**HP PERMIT NUMBER:** HP-0701-2025

**PROPERTY ADDRESS:** 1707 South Detroit Avenue

**HP PERMIT NUMBER:** HP-0702-2025

**HP PERMIT NUMBER:** HP-0704-2025

Google Street View- East side of House

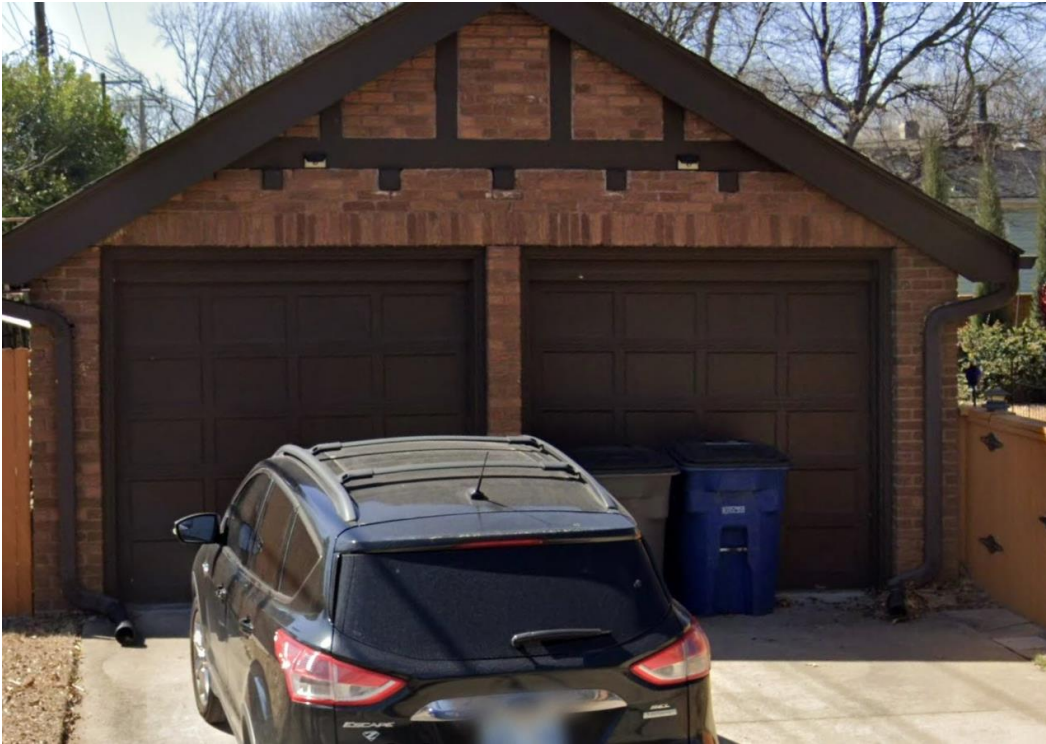
1. The applicant proposes the replacement of the existing doors on a detached garage. The garage is located in the street yard, making this change reviewable by TPC. The applicant states the current garage doors are heavy and in disrepair. The proposed replacement door is an insulated metal door with the color to match the trim and

appearance of existing door. At the September 11th, meeting, the subcommittee recommended approval. Cited guidelines, A.3.5

Window #9 & #10 Interior

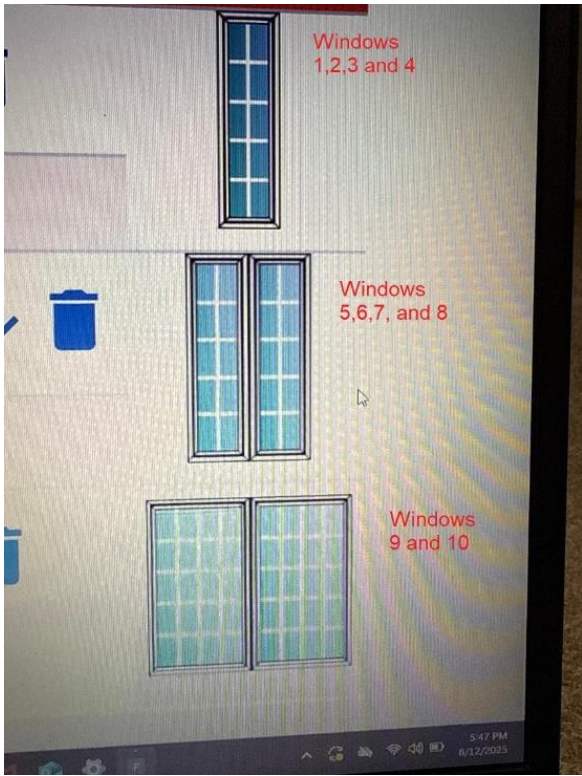
1. The applicant proposes the replacement of two steel bay single paned windows and one single paned steel casement window with double-paned argon filled, white vinyl windows. The applicant states the replacement is to mitigate head and cold loss drafts. Additionally, the applicant states that all other windows in the house were replaced with vinyl windows from the same company (CDK) in 2012 with TPC approval. The replacement windows would have the same dimensions as existing windows with exterior raised muntins (current muntins are 5/8" wide, the new ones would be 7/8". Replacements would maintain the same divided light pattern of existing windows. At the September 11th meeting, the subcommittee recommended approval. Cited guideline: A 4.5
